CODY ROAD VOA HOUSING SUBDIVISION

APPLICATION NUMBER 12 DATE May 4, 2006

APPLICANT Cody Road VOA Housing Subdivision

REQUEST Subdivision

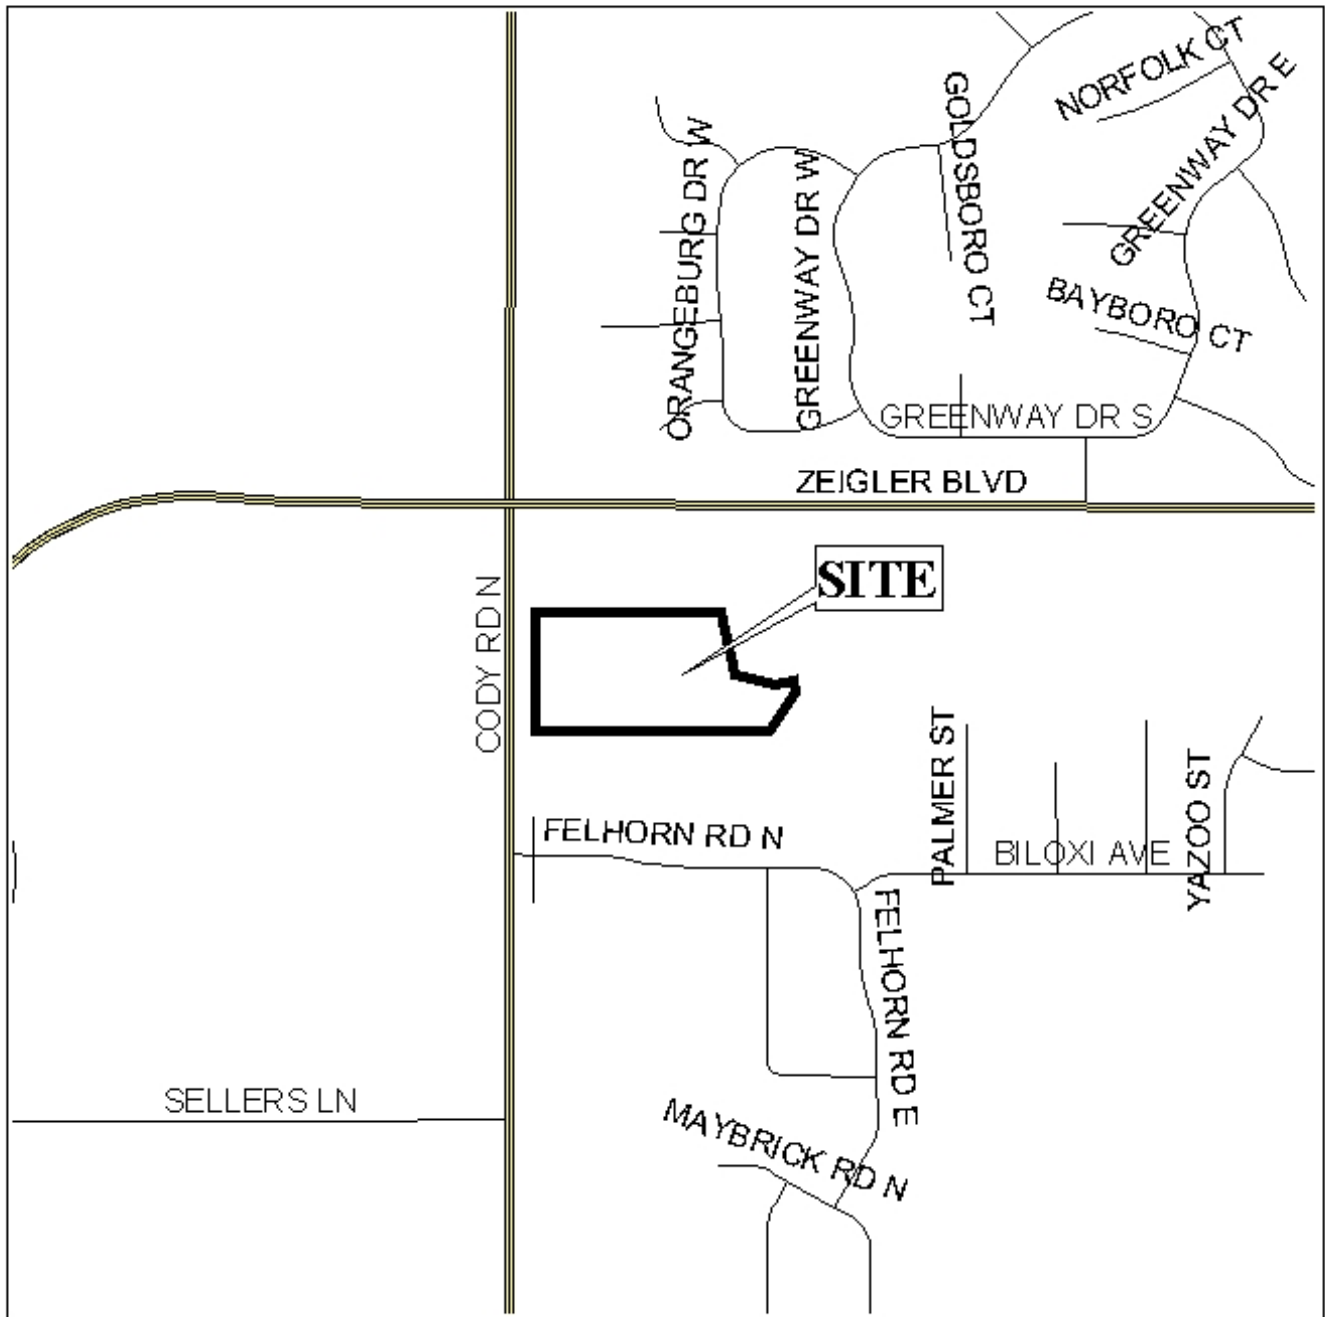
Engineering Comments: Minimum Finished floor elevation required on any lot affected by x-shaded or AE flood zone. Engineering will require dedication of the AE Flood zone as a “Floodplain Easement”. Development must comply with all stormwater and flood control ordinances. Any work performed in the right of way will require a right of way permit. The applicant is responsible for verifying if the site contains wetlands. The site can be checked against the National Wetlands Inventory on the COM web site Environmental Viewer. If the site is included on the NWI, it is the applicant’s responsibility to confirm or deny the existence of regulatory wetlands.

Traffic Engineering Comments: Driveway number, sizes, location and design to be approved by Traffic Engineering and conform to AASHTO standards.

Urban Forestry Comments: Property to be developed in compliance with state and local laws that pertain to tree preservation and protection on both city and private properties (State Act 61-929 and City Code Chapters 57 and 64). Preservation status is to be given to the 57” Live Oak Tree located on the West side of Lot 1. Any work on or under this tree is to be permitted and coordinated with Urban Forestry; removal to be permitted only in the case of disease or impending danger.

The site fronts Cody Road, which has an 80-foot right-of-way; as this is a planned major street requiring a 100-foot right-of-way, dedication sufficient to provide 50 feet from the right-of-way should be required. As a means of access management, the site should be limited to a single curb cut per lot. The plat does not show the 25-foot setbacks, which will be required on the final plat.

While proposed Lot 2 is irregularly shaped, it does have ample frontage on Cody Road, and the configuration in this case appears to respond to the presence of the AE floodplain toward the rear of the lot. Configuring Lot 1 so that it does not contain any land in the floodplain will make grants applications for the applicant (a non-profit organization) less complicated since floodplain issues will not be inherent in Lot 1; should the property change hands, it still seems practical to leave floodplain responsibilities with fewer owners and have other less-complicated parcels on the market. For this reason, and because the site is commercially zoned and would not otherwise seem to pose orientation or access issues, this configuration appears appropriate.

The plat meets the minimum requirements of the Subdivision Regulations and is recommended for Tentative Approval, subject to the following condition: 1) dedication of sufficient right-of-way to provide 50 feet from the centerline of Cody Road; 2) the placement of a note on the final plat stating that the site is limited to a single curb cut for each lot; and 3) the placement of the 25-foot setbacks on the final plat.
